Staff Summary Report

SUBJECT: Hold a public meeting for a Development Plan Review for MCDONALDS RESTAURANT, located at 1740 East Elliott Road.

DPR11232 – Development Plan Review including site plan, building elevations, and landscape plan.

SITE PLAN

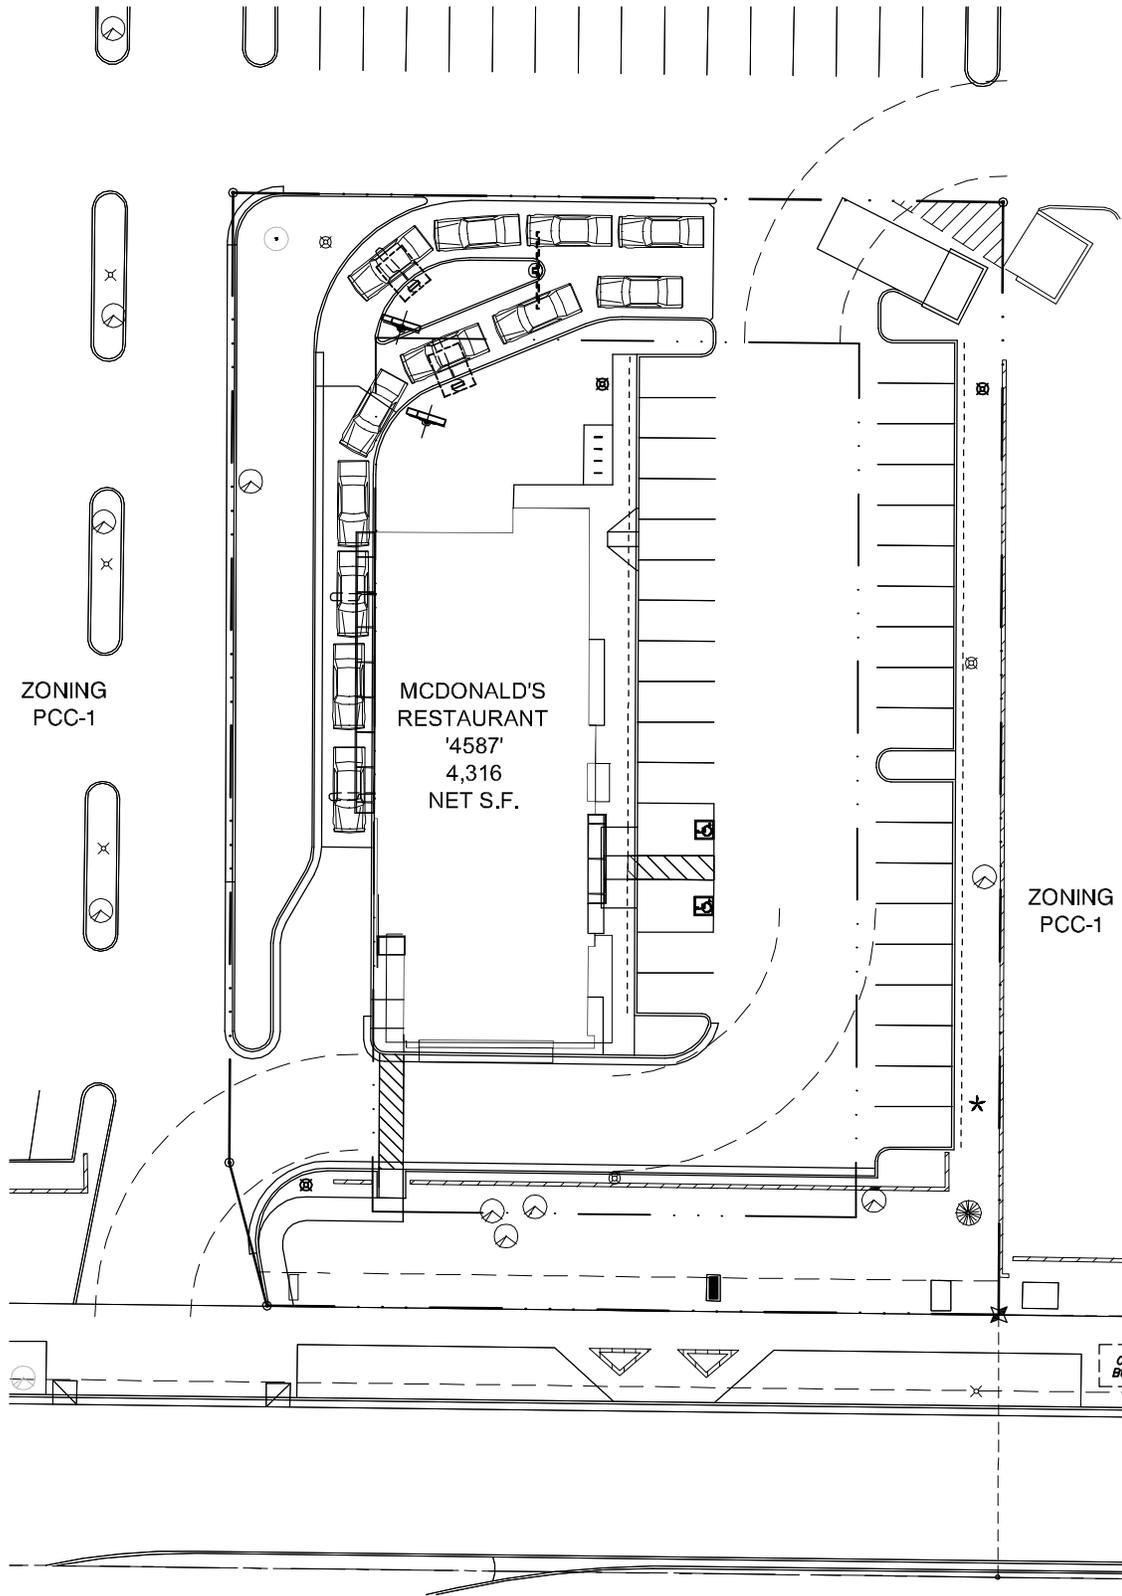
2. Utilize raised curb as tire stop as included in Site Plan vignette sketch on Preliminary Site Plan Review markup, dated 01/04/2012. Do not offset curb between disabled accessible and standard parking spaces.

3. Reconcile discrepancy in paving layout between the site and landscape plans and the grading and drainage plan, particularly as relates to the disabled accessible walkway that connects the restaurant to the Elliot Road sidewalk.

4. Relocate buried retention structure west into the drive aisle so it does not interfere with tree planting areas.
5. Exterior doors to fire riser room, electrical service entrance section (S.E.S.) room and freezer do not require vision panels.

11. Adjust position of freestanding light on east property line. Maintain minimum 20'-0" separation from the existing mesquite (T-8).
12. For restroom security lights, provide fifty percent (50%) night lights and activate full lights by automatic sensors or key switch.

ELEVATIONS

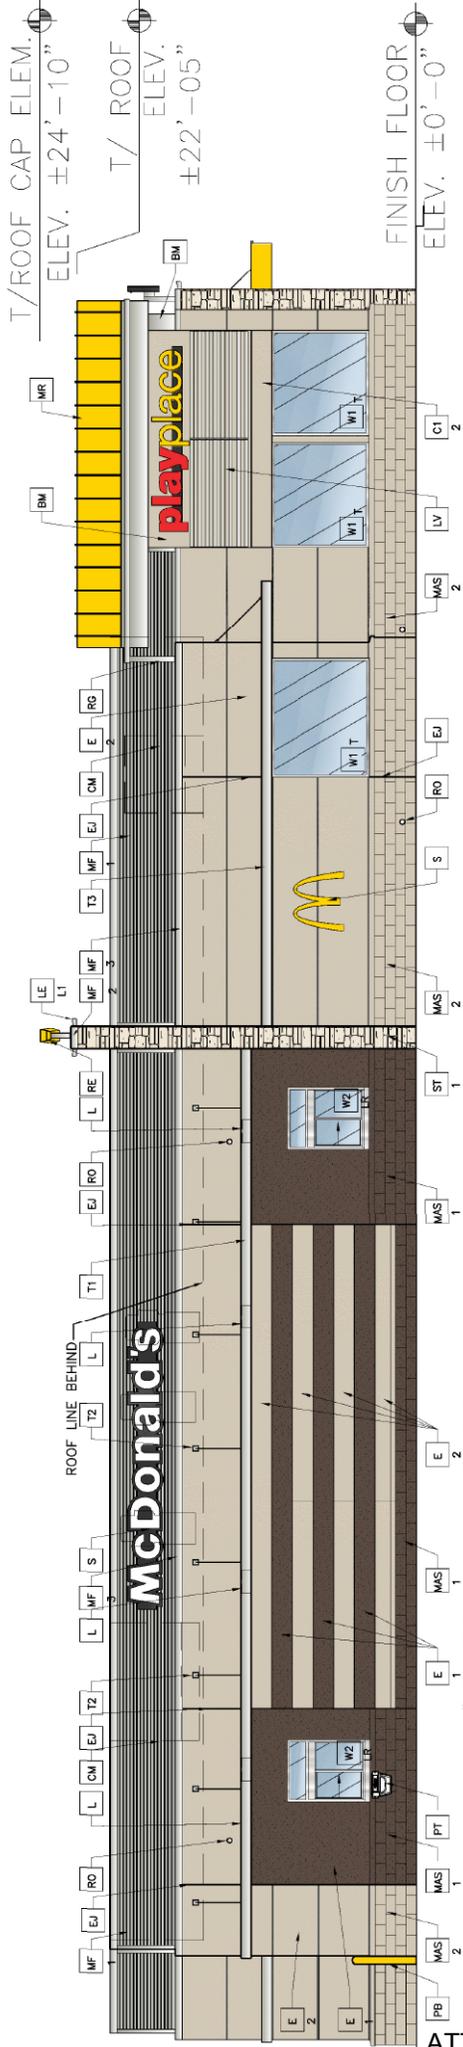
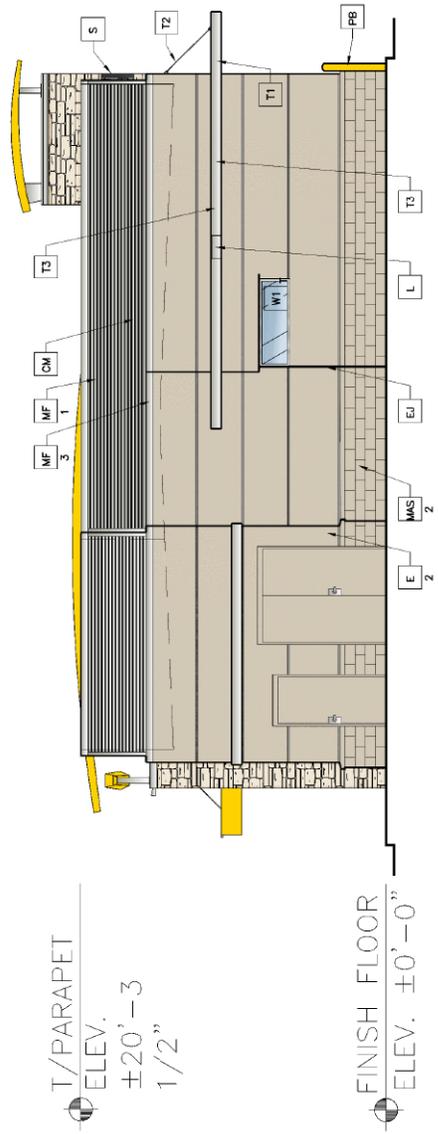
8. The materials and colors are approved as presented:
 - a. Accent stone veneer at front wall and at entrances, manufacturer: Boral Stone Products, Pro-Fit LedgeStone Southwest

- b. Exterior finish insulation system (EIFS): smooth texture surface
 - c. EIFS paint accent stripes, manufacturer: Benjamin Moore, color: Mink - #2112-10.

- d. Exposed split face concrete masonry unit (CMU) accent stripes, integral color: Cocoa Brown
 - e. EIFS paint field, manufacturer: Benjamin Moore, color: Huntington Beige - #HC-21.

- f. Exposed split face CMU field, integral color: Mustard
 - g. Corrugated metal panel at parapet, manufacturer: Metal Era, color: Cityscape (gray)
 - h. Metal trellis at pick up drive lane: color Cityscape (gray)

- i. Standing seam metal roof at Play Place roof and south and east trellis, color: Pantone 109C (yellow)
 - j. Storefront frame: clear anodized aluminum

- k. Glazing, manufacturer: Trulite, 1" Solarban 60 #2 / clear
